Planning Commission Application Summary

Project Name: Hidden Canyon Estates Preliminary Subdivision Plat
Address: Approximately 15000 South Suncrest Dr.
Current Zoning: RM (Multi-family Residential) and C-3 (Commercial) zone
Hearing Date: March 24, 2016

To: Draper City Planning Commission
Business Date: March 24, 2016

EXHIBIT E
PRE-DEVELOPMENT GRADING PLAN

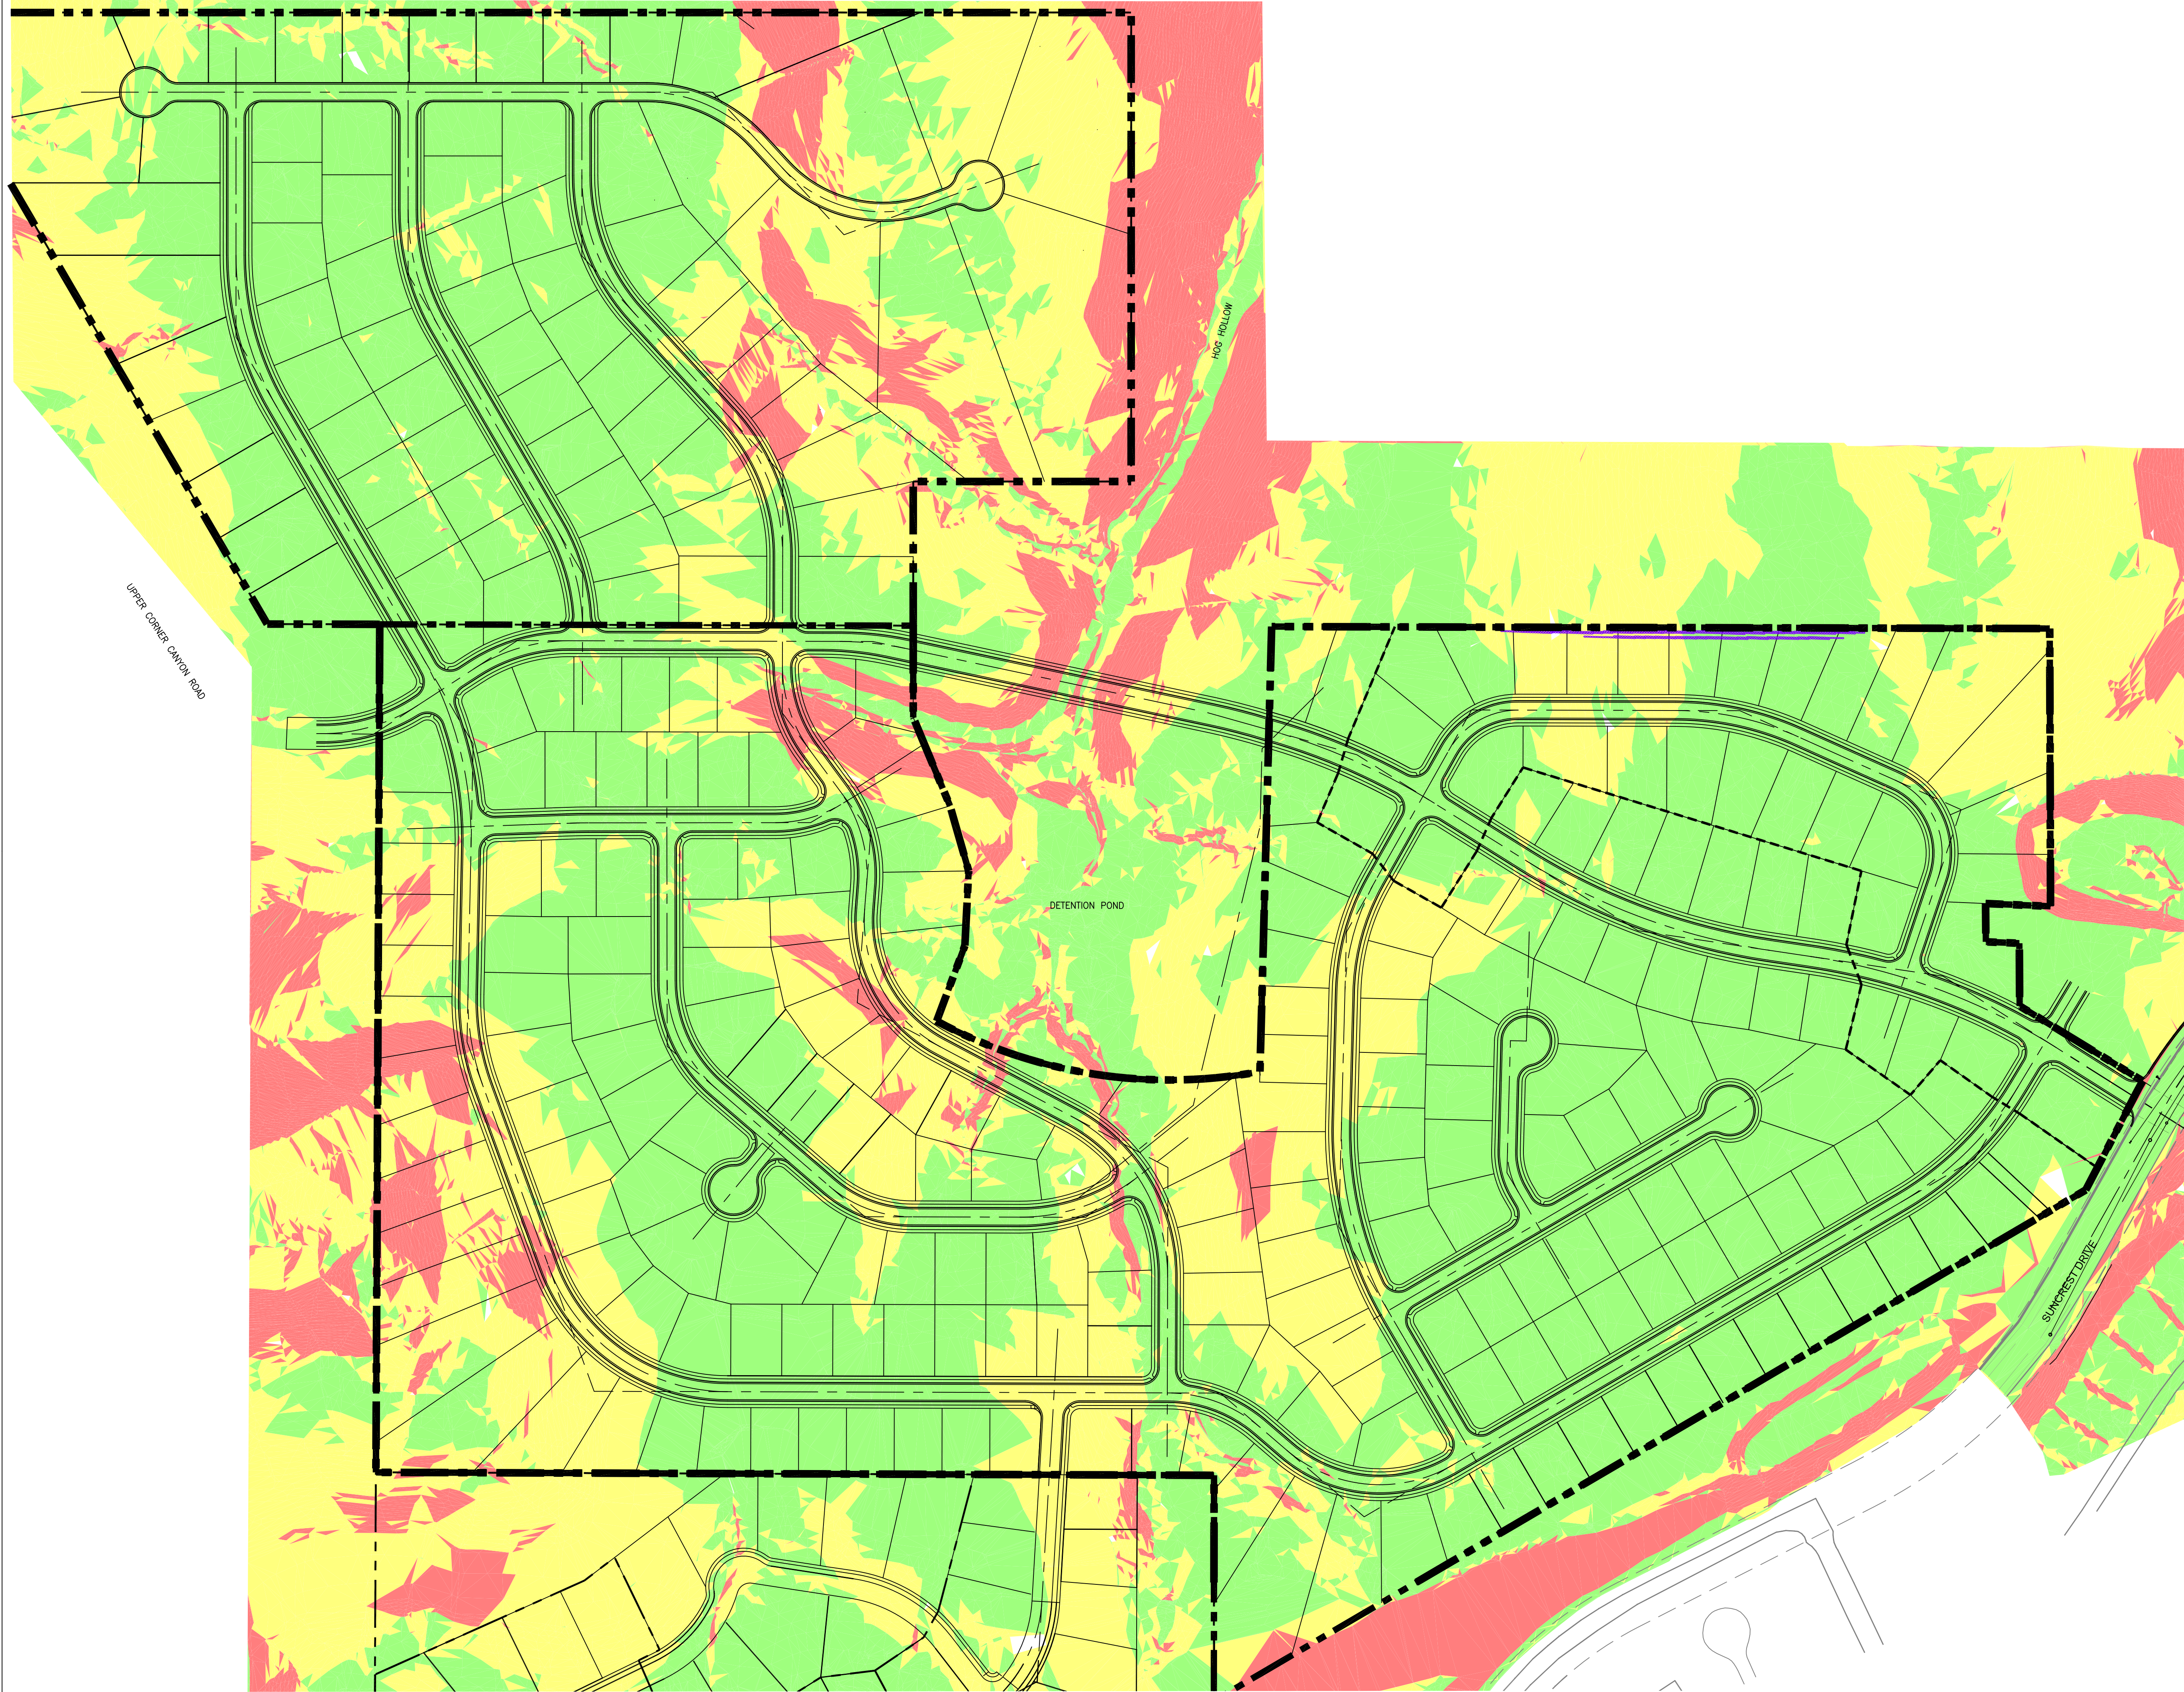
Slope Development. The applicant is requesting a deviation to build within some areas of 30% slope or greater. Exhibits E and F show the pre-development slopes and the post-development slopes. There are approximately 43 out of the 300 lots that will be affected, with those lots containing least 30% or greater slope areas. Some of the lots will be mass graded to allow development, while some will remain in their natural slopes. Draper City Municipal Code 9-16-040(A) outlines guidelines the Planning Commission can use to approve encroachment into slope area.

City Staff and the City's geo-technical and geo-hazards consultants have reviewed the grading plans and determined that the proposed plans are not concerning in regards to slope.

FIGURE R-2

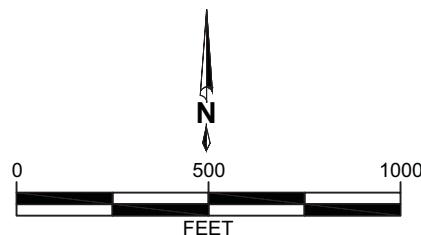
Test pits TP-10, TP-13, and TP-19, (see IGES Figure R-2, attached), are not located within the suspect features and TP-20 is depicted at the edge of one of the features. During the geologic field reviews:

Test pits TP-10, TP-13, and TP-19, (see IGES Figure R-2, attached), are not located within the suspect features and TP-20 is depicted at the edge of one of the features. During the geologic field reviews:

- a. *Draper City request IGES provide additional data to substantiate IGES’ conclusion that the “... features are erosional in nature.”.*
 - b. *Draper City require a scoping meeting (should IGES choose to perform additional field exploration) prior to commence of any field work, as stipulated in the Draper City geologic hazard ordinance.*
5. *SA recommends Draper City request IGES provide adequate data to support the retraction of any statements in prior IGES reports/letters.*
 6. This letter constitutes the third review letter. In order to clarify remaining issues, *SA recommends Draper City schedule a project meeting with the Applicant and Consultant (prior to the Consultant submitting a response letter), to discuss the geologic issues presented herein.*

TYPICAL ROAD CROSS-SECTION

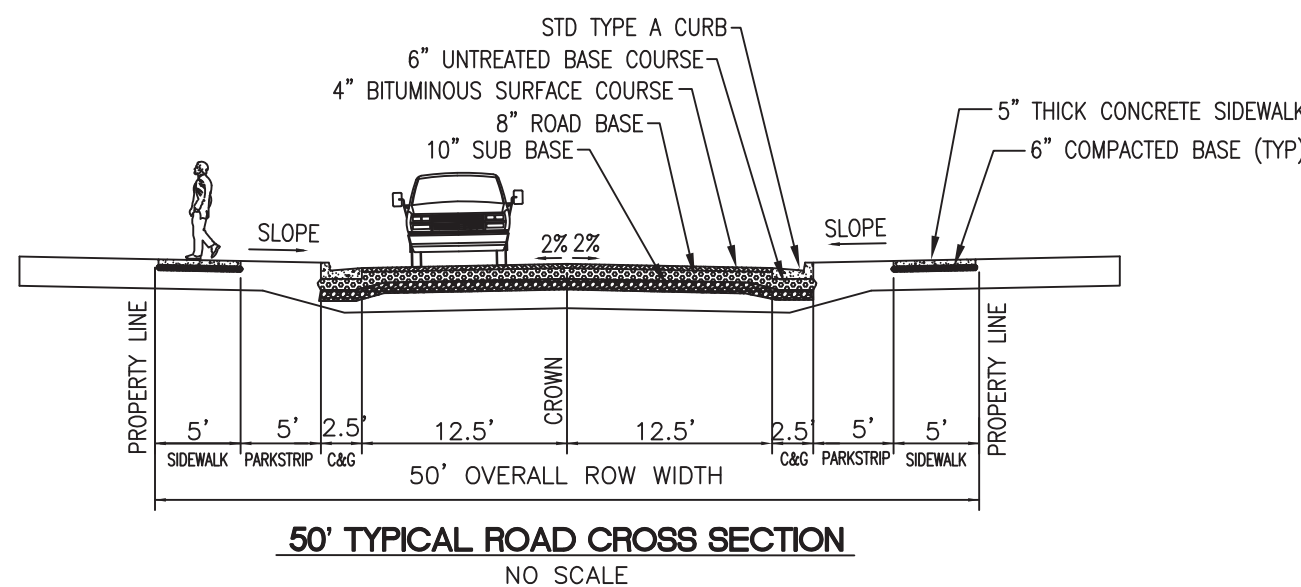
Street Design: The applicant is requesting approval of a street design modification. They are specifically requesting a 50-foot wide public right-of-way. The Draper City Master Transportation Plan calls for a minimum 56-foot wide right-of-way on mountain local roads. The difference between the two is the amount of asphalt, shoulder and curb and gutter provided. The City's typical mountain local street standard calls for 24-feet of travel lane, with 4-feet of shoulder and 2-feet of curb and gutter per side of the street center line, along with a 5-foot side walk and 5-foot parkstrip on either side. The applicant is proposing 25-feet of travel lane, with 2.5-feet of curb and gutter per side of the street center line, and 5-feet sidewalk and 5-feet parkstrip on either side. The cross section for the proposed streets can be found in Exhibit K of this staff report.
